Architectural Review  
and Historic Preservation Board  
Special Memo

File: AR 19-15

RE: AR 19-15 (Sloop Medical Building)  
Jan Court at Forest Avenue -- APN 002-210-066 et al.

SITE DIMENSION & FIRE LANE PLAN  
MEDICAL BUILDING DEVELOPMENT  
JAN COURT  
SLOOP & SLOOP

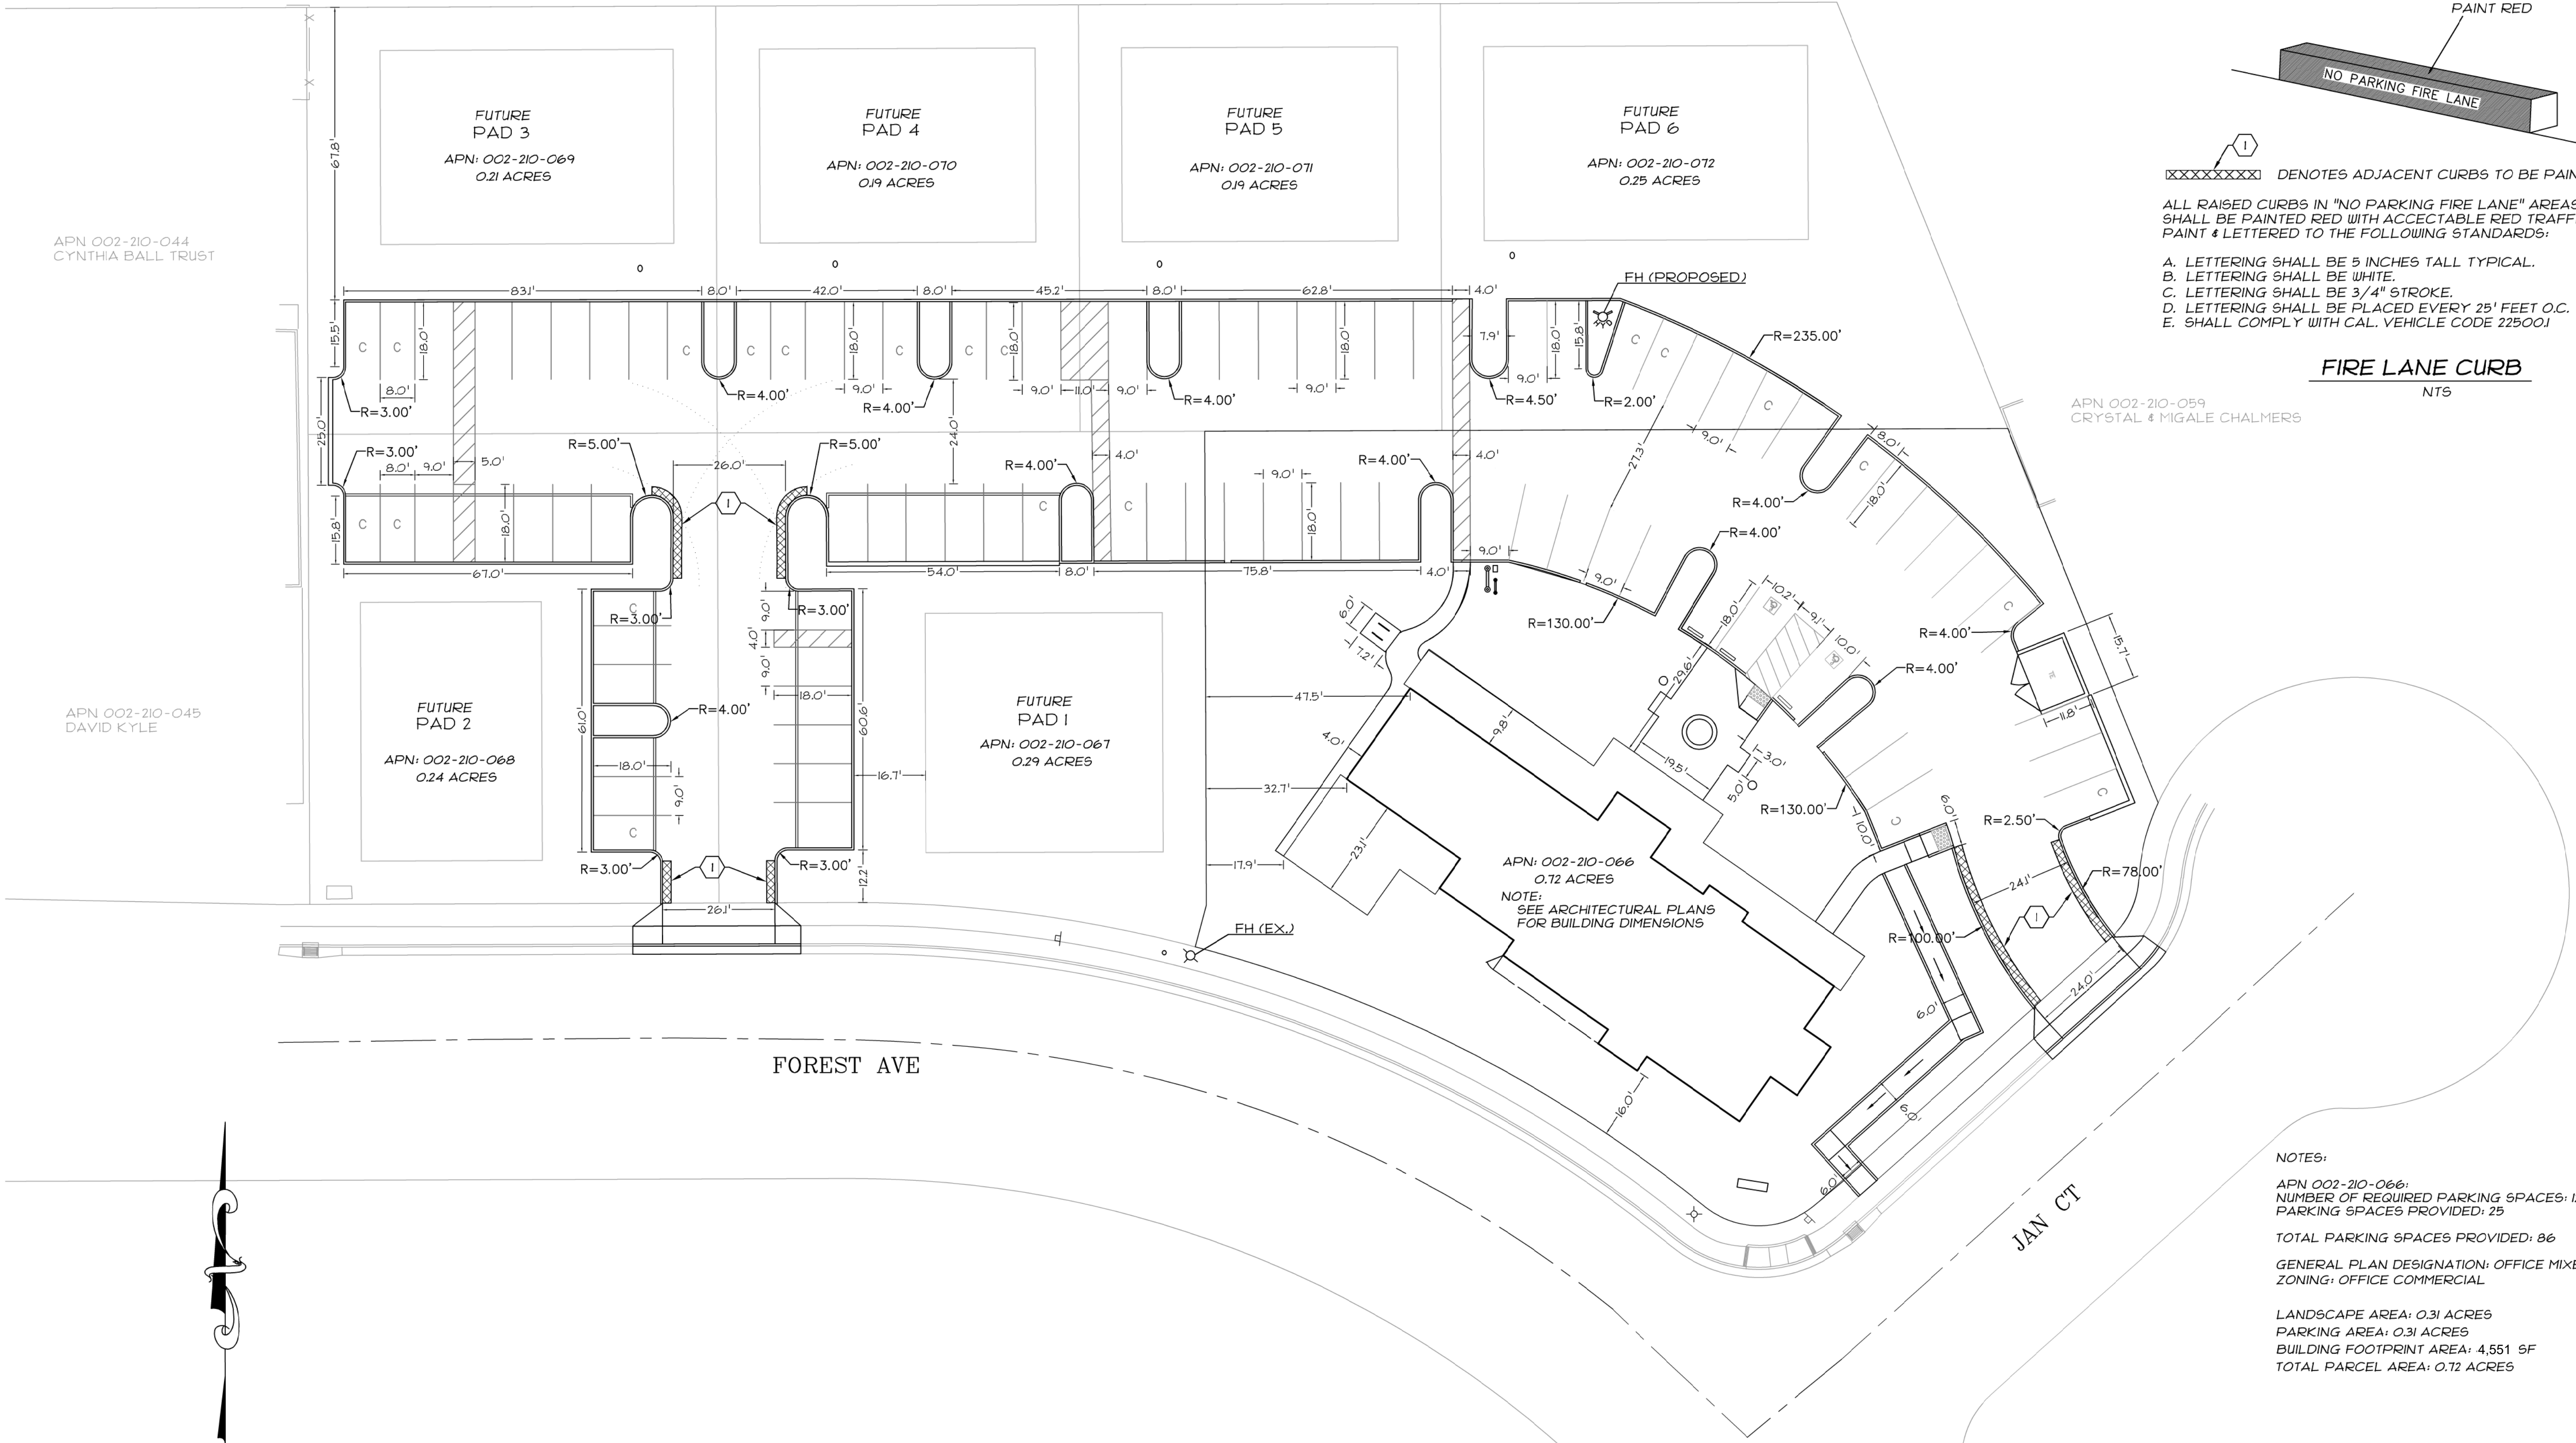
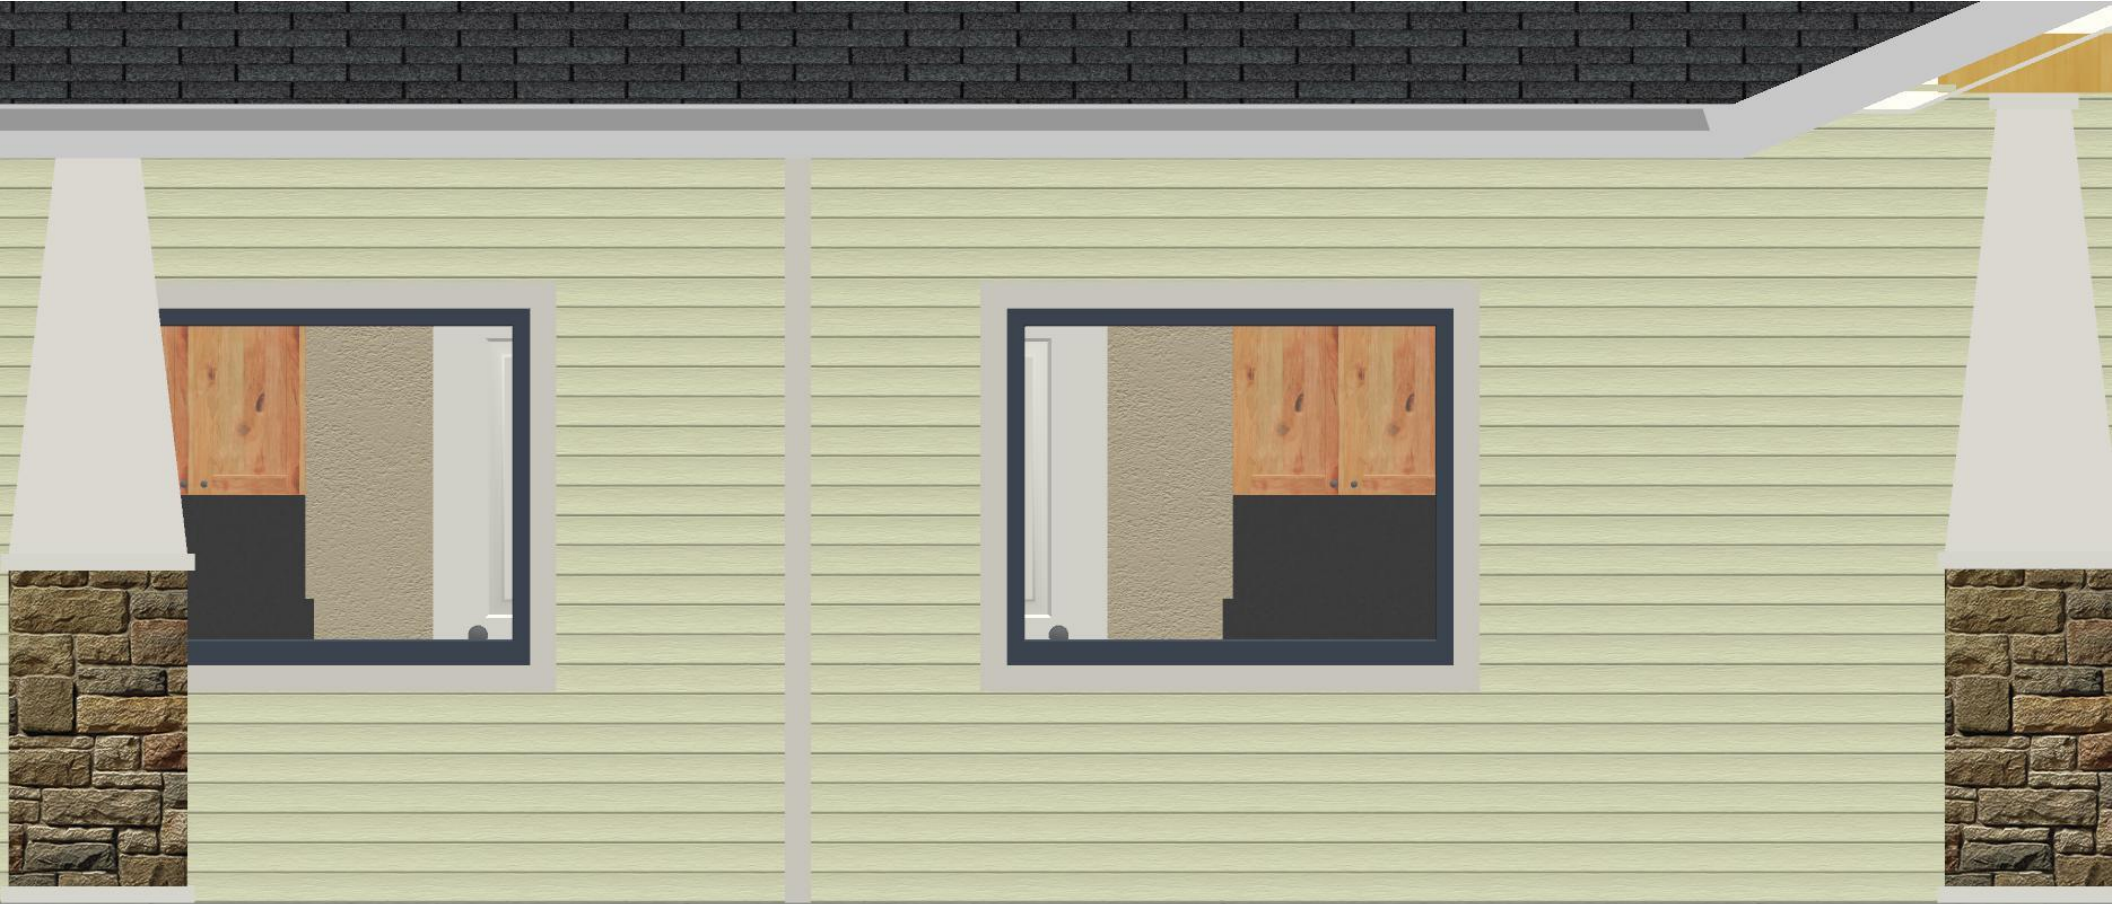
Since the date of the last meeting, the building footprint of the proposed medical building was reduced from 5,931 square feet to 4,551 square feet. Per Chico Municipal Code (CMC) Section 19.70.040, the required number of vehicle parking spaces for medical office uses is calculated at a rate of one space per 250 square feet of building area. As a result of the reduction in building size, the number of required parking spaces is 18. Twenty-five parking spaces are proposed on the primary project parcel (APN 002-210-066), satisfying onsite parking requirements. An additional 61 vehicle parking spaces are proposed to serve future office buildings in the complex, for a total of 86 spaces proposed throughout the project site. Future

The proposed building would be set back from the intersection with landscaped areas in front and its parking area behind (see **Attachment B**, Site Plan). Additional new parking areas would extend through the site to the west. Twenty-three parking spaces are required for the new use, and 20 are provided wholly on the instant parcel, with five more partially present. 61 more would serve future buildings in the complex. With approximately 20,000 square feet of additional office space remaining, ultimate build out of the complex will likely be slightly overparked. Four bike parking spaces are provided in uncovered racks.

6. Applicant shall provide a structural cover over the bicycle parking area or relocate the bicycle parking to a covered location within 20 feet of the front building entrance.
